Engine does not start with fault code P30083C in MRD1 (CDI)

Topic number	LI15.30-N-078528
Version	1
Function group	15.30 - Starter
Date	11/12/24
Validity	Sprinter 907 with OM654 Engine
Reason for change

Attachments	
File	Description
wiring.png

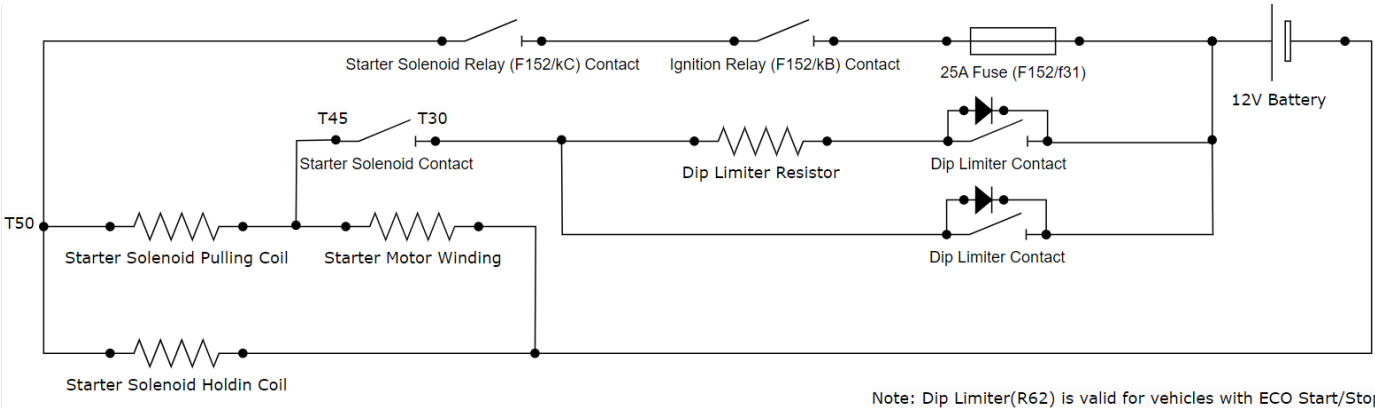
- The diagram below illustrates that if there is a problem with either the 'Dip limiter contact' or the 'Starter solenoid contact' closing, the starter will fail to crank the engine.
- When the engine start button (S2/2) is pressed continuously, the starter solenoid's 'Pulling coil' will remain activated until the engine ECU deactivates the starter solenoid relay (F152/kC). This should occur within a maximum of 60 seconds.
- Due to the continuous high current draw from the starter solenoid's pulling coil, the 25A fuse (F152/f31) may blow.

- 1. We recommend replacing the 25A fuse with a 30A fuse for F152/F31.
- 2. Do not press the engine start button (S2/2) continuously, as this may cause the starter solenoid coil to overheat and become permanently damaged.
- 3. If the engine does not crank or start, please advise the customer to refer to the procedure outlined in the owner's manual.
- 4. If the engine does not crank or start, instruct the customer to avoid pressing the engine start button (S2/2) continuously or frequently.
